**CITY OF UNLEY**  
**COUNCIL ASSESSMENT PANEL**

**21 January 2020**

**ITEM 1****DEVELOPMENT APPLICATION – 090/398/2019/C2 – 102 EAST AVENUE,  
CLARENCE PARK SA 5034 (CLARENCE PARK)**

ATTACHMENT 1 – ACCESS TO DWELLING 2

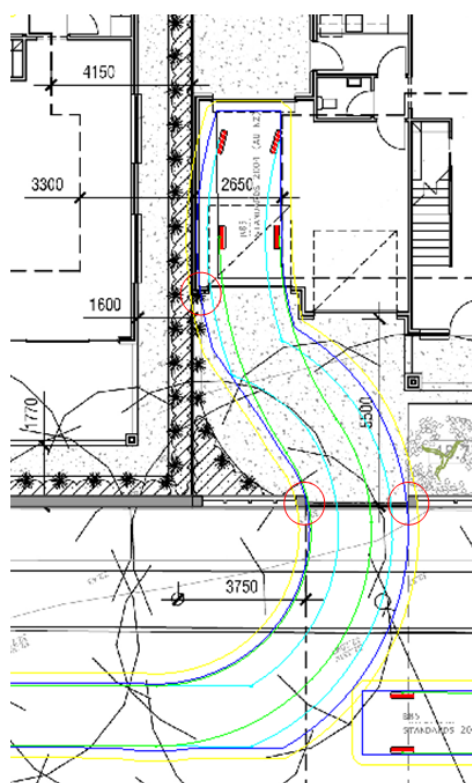
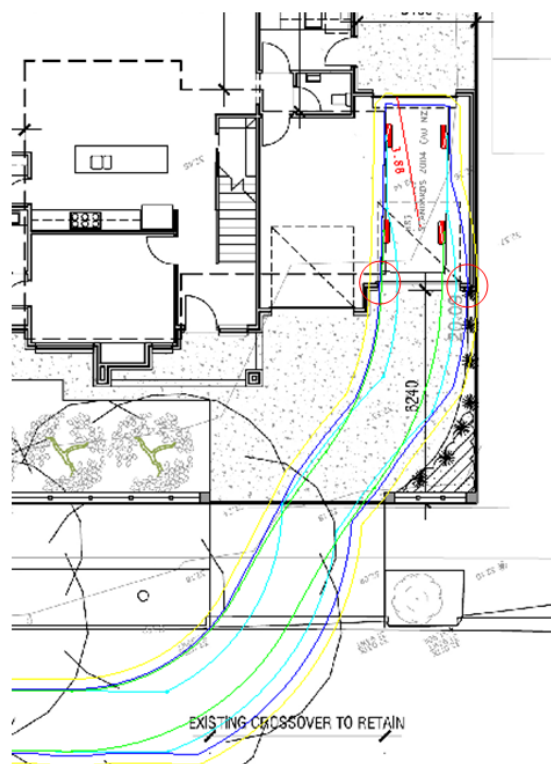
Manoeuvrability in and out of the garages has been checked with a B85 vehicle, which represents the likely size of passenger vehicles used in a residential property. This process indicated the following:

- Access to dwelling 1 is acceptable.
- Access to dwelling 2 would be very difficult due to the location and narrow width of the gate, as shown in attachment 1 with conflict points circled in red. In practice it would likely require five movements to enter the eastern garage space (and similar when reversing out).
- Access to dwelling 3 would be difficult, as shown in attachment 2 with conflict points circled in red. In practice it would likely require at least three movements to enter the western garage space (and similar when reversing out).

The applicant has since amended the driveway and crossovers to allow for easier access and manoeuvrability.
